CERTIFICATE OF APPROPRIATENESS ISSUED: August 20, 2025 EXPIRATION: August 20, 2026

This letter provides you with confirmation that the proposed changes to your designated historic property, the J.L. Van Horn Property at 1111 Remington St., have been approved by the City's Historic Preservation Division because the proposed work meets the criteria and standards in Chapter 14, <u>Article IV</u> of the Fort Collins Municipal Code as well as the requirements of Section 5.8.1 of the Land Use Code.

- 1) Replacement of settling, non-original rear enclosed porch with similarly designed enclosed porch with slightly larger footprint, engineered wood lap siding, wood doublehung windows, wood French doors facing west/rear yard (see attachments), black architectural asphalt shingles, and painted in Behr Melting Icicles and Black
- 2) Repair and tuckpointing of brick on southwest corner of house
 - a. Due to the age of the home, type N or O mortar must be used. Using a harder mortar may damage the softer brick. Care must also be taken to match the color and application of the existing mortar to blend the repair in with the rest of the home.

SUN POURCH NEW CONSTUCTION IIII REMINGTON ST, FORT COLLINS, CO 80524

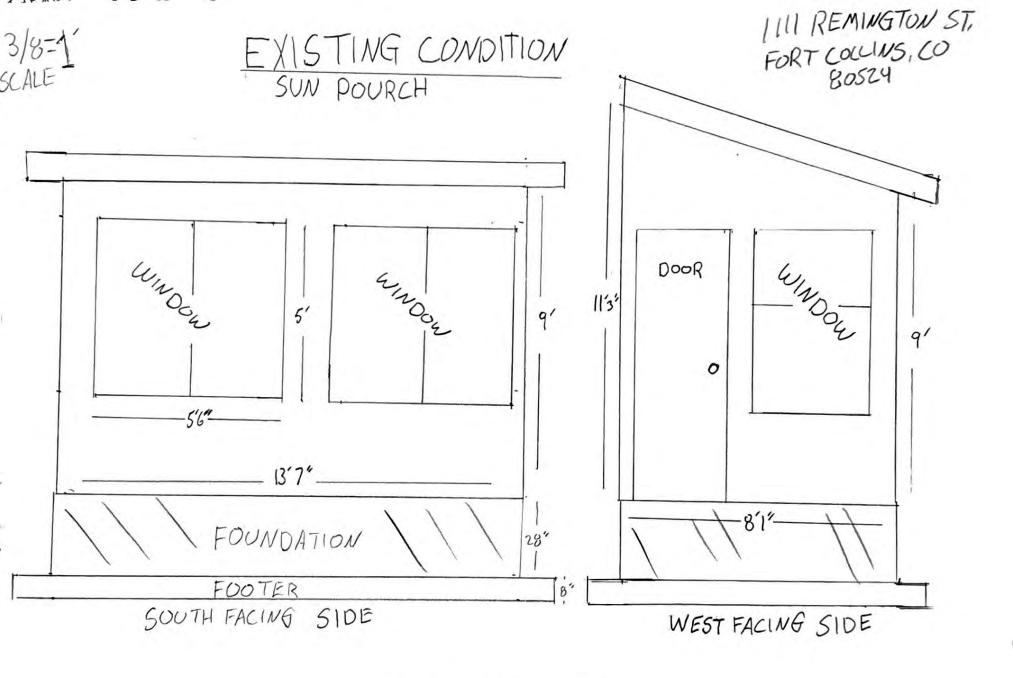
Yes, that all sounds great! I'm not really concerned about the roof ridge having to go up a little further on the building because it's unlikely to interfere with architectural features like the windows.

As far as materials go, a lap siding similar to the existing would be appropriate (you're not locked into the exact style or reveal width) and would be more compatible with the house than a boardand-batten. More/big windows would also be just fine. As you're selecting material types, please avoid vinyl for windows, siding, the door, etc. – Vinyl is really not a great substitute in terms of its ability to imitate wood and also in its life expectancy. I also recommend avoiding windows with divided lights (i.e., having a grille or muntins), since that window type isn't seen anywhere on the house.

After a first look, I do have a couple of questions to fill in a couple details, when you have a moment. What is the type of windows proposed (e.g., fixed, horizontal sliders, double-hung sash windows, awning windows, etc. – If multiple types, it might be easier to add labels to the elevation drawings)? Also, what is the material of the French doors?

I would propose that the windows would be double hung sash windows with wooden frames, all of the same size and shape.

The French doors would be wood frame, wood door, glass insert.
